Factory Service Bulletin

SUBJECT: MEMORYMOOG AUTOTUNE UPDATE BULLETIN: 840A DATE: 10/6/83
Serial numbers below 2723
Software Revision 2.4 (C, 0, ENTER displays 83)
Kit Part Number 997-044667-101

COMMON ANALOG MEMORYMOOG 2 AUTOTUNE

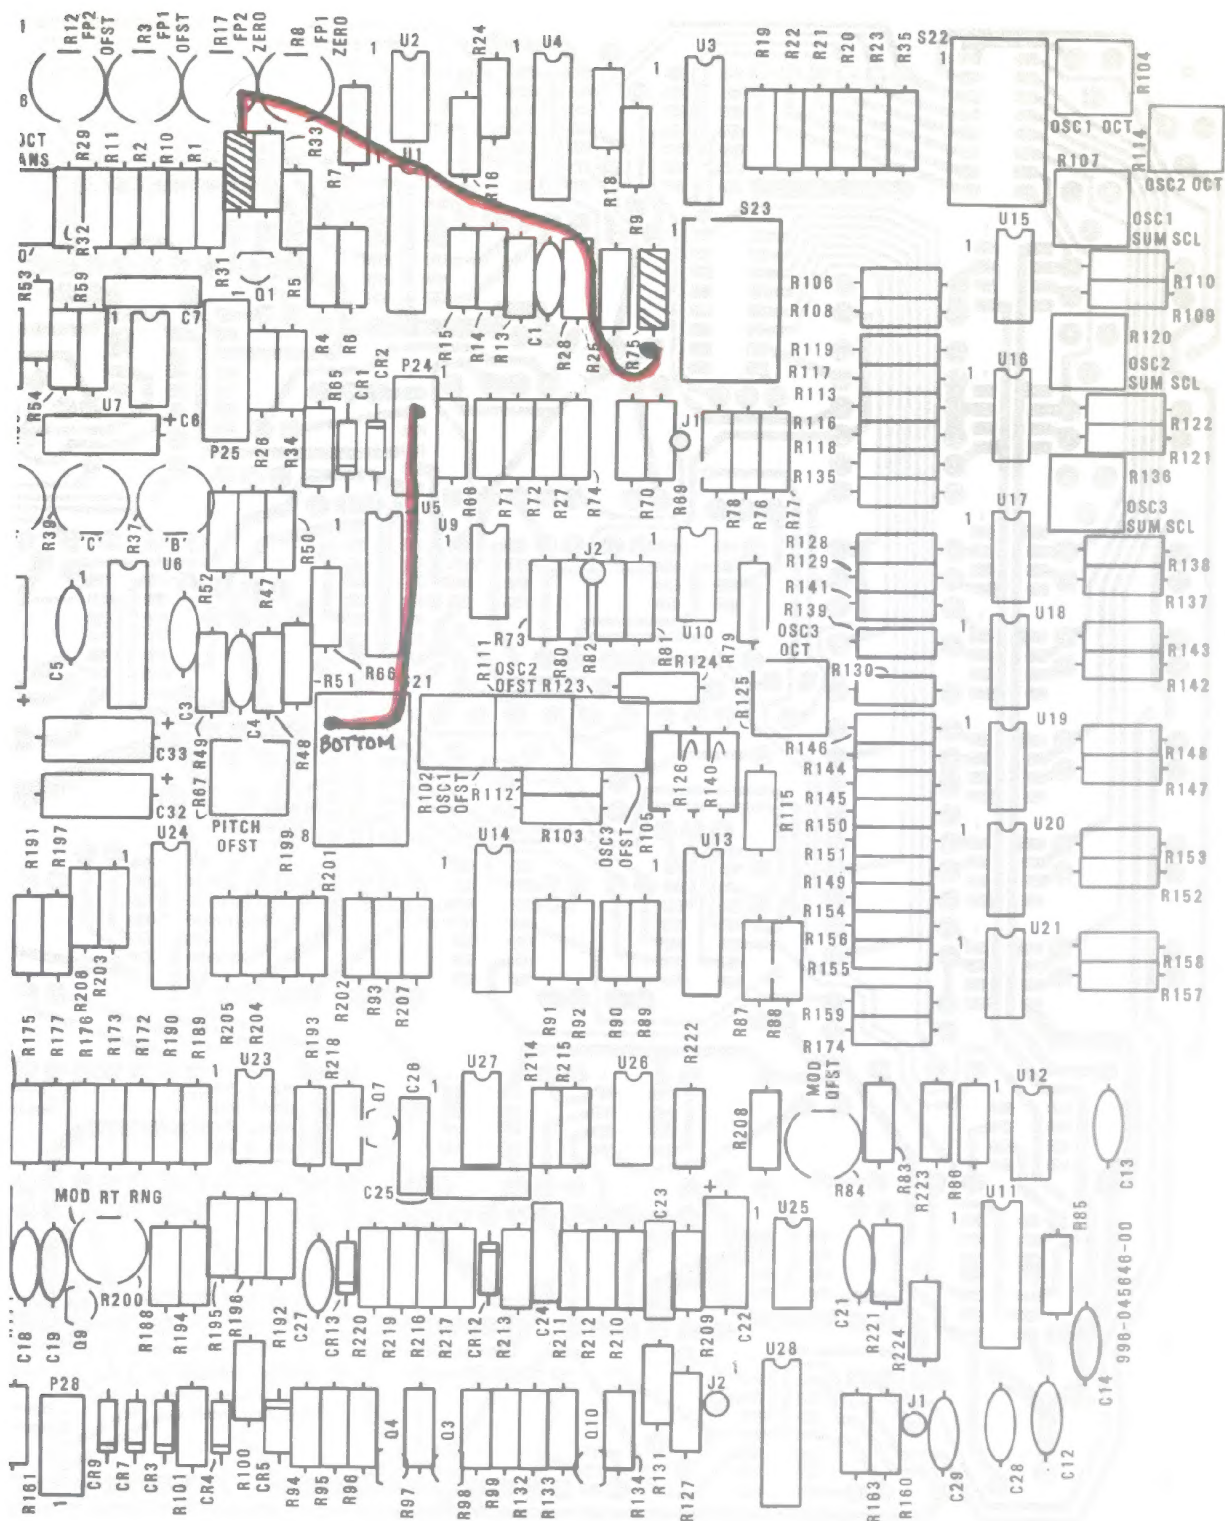
Reroute the wiring around U4A as follows on the TOP side of the board:

- 1) Cut the rear end of resistor R31, the end nearest R17.
- 2) Tack-solder the free end of R31 to the end of a 3" (70mm) insulated jumper wire (1/2 of part number 996-045646-962).
- 3) Tack-solder the other end of the 3" (70mm) jumper to the FRONT side of R75 as shown.

On the schematic, this changes the connection of R31 from its present location at Pin 2 to its new location at Pin 1 of U4A.

Next, change the routing of P24-2 connector on the BOTTOM of the board by tack-soldering a 2.5" (63mm) insulated jumper between P24-2 and S21-2 (1/2 of part number 996-045646-962).

DMUX BOARD AUTOTUNE

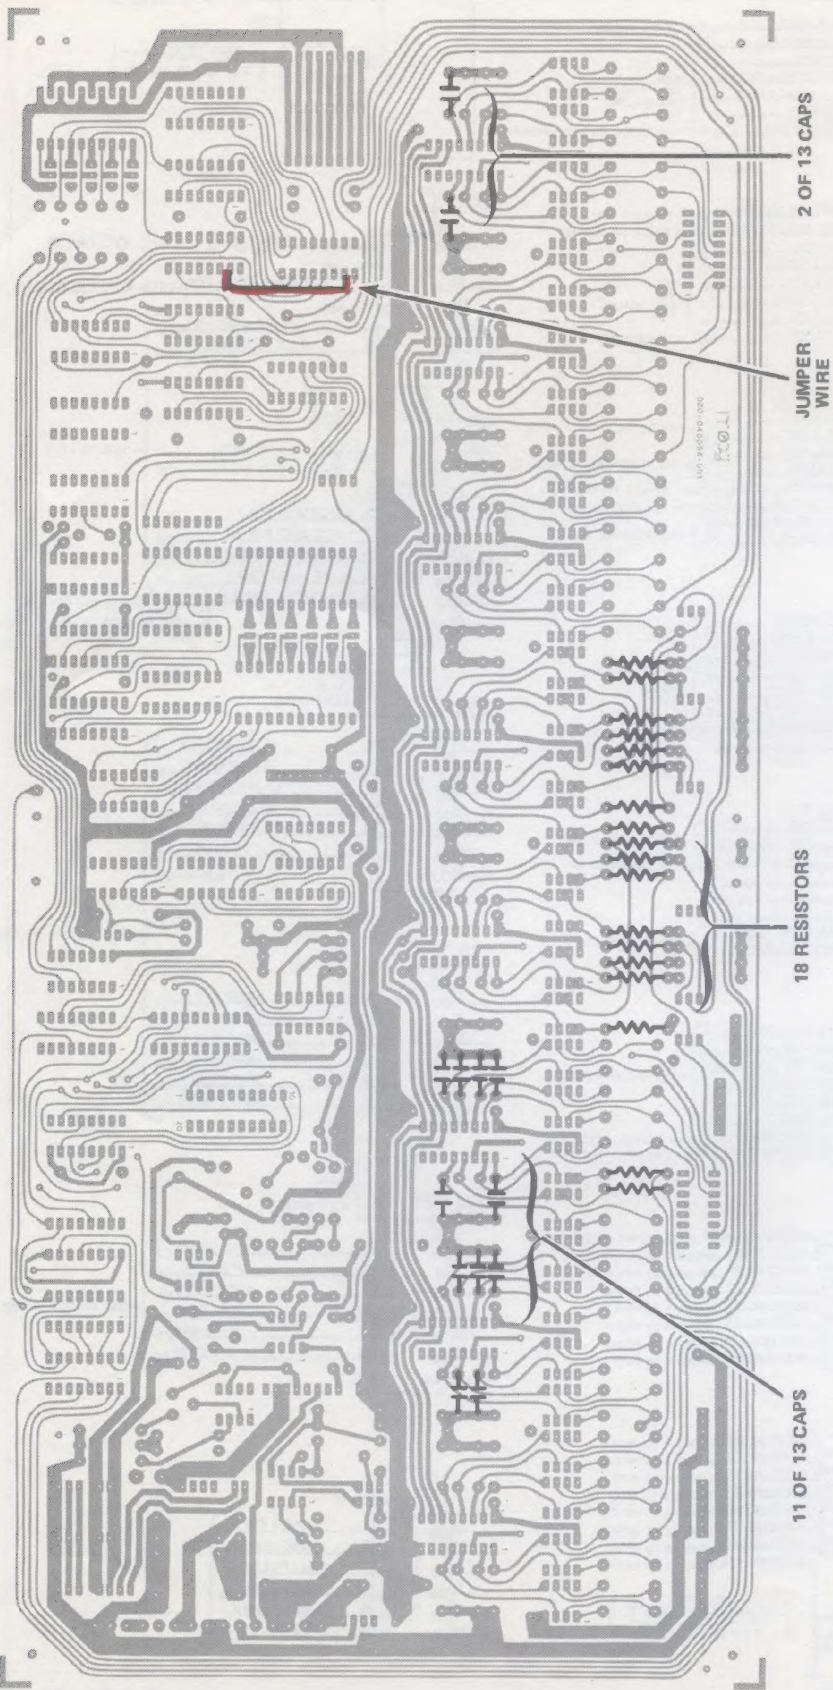
REPLACE THESE CAPACITORS WITH 75 WATT SOLDERING IRON
C45, C46, C41, C40, C39, C51, C52, C49 Replace with .047uf capacitors,
C48, C47, C50, C20, C18 (13 capacitors part # 946-041978-473.
mounted left to right and top to bottom).

REPLACE EVEN NUMBER RESISTORS FROM R84 THROUGH R118 WITH 45 WATT SOLDERING IRON.

R86, R84, R98, R96, R100, R92, R90, R88, R94, R102, R114, R118, R104, R112, R108, R110, & R116 '18 resistors as mounted from left to right).	Replace with 17.4K 1% resistors, part number R106, 853-421742-031
--	---

Add a 1.5" (38mm) insulated jumper from S-55 pin 2 to U54 pin 2 on the BOTTOM of the board (part number 996-045655-962).

1. IDENTIFY ALL PADS TO BE UNSOLDERED WITH A MAGIC MARKER (CAPACITORS REQUIRE 75 WATT SOLDERING IRON).
2. CHANGE ALL APPROPRIATE RESISTORS AND CAPACITORS AT ONE TIME.
3. SOLDER IN NEW COMPONENTS AND THE JUMPER WIRE.
4. THOROUGHLY CLEAN FLUX AWAY WITH ISOPROPYL ALCOHOL (THIS WILL ALSO REMOVE MAGIC MARKER).
